MIL-A-28729B(EC)
AMENDMENT 2
26 May 1981
SUPERSEDING
AMENDMENT 1
12 April 1976

MILITARY SPECIFICATION

ANTENNA COUPLER GROUP, CU-1382( )
(HF BROADBAND, WIDE DYNAMIC RANGE)

This amendment forms a part of Military Specification MIL-A-28729B(EC) dated 15 May 1975.

FIGURE 1A. Types III and IV mounting panel "

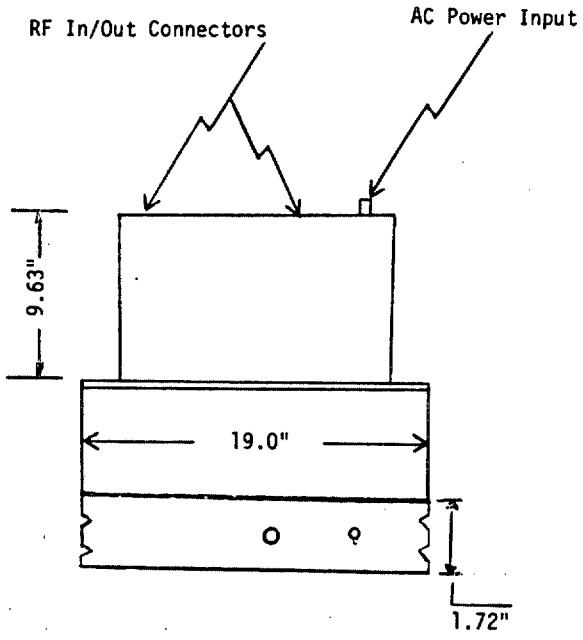
* 3.2.17, line 2: Delete "It" and substitute "Types I and II"; after line 11: Add "Types III and IV shall be constructed as shown in FIGURE 1A."

* After FIGURE 1, Add the following as FIGURE 1A:
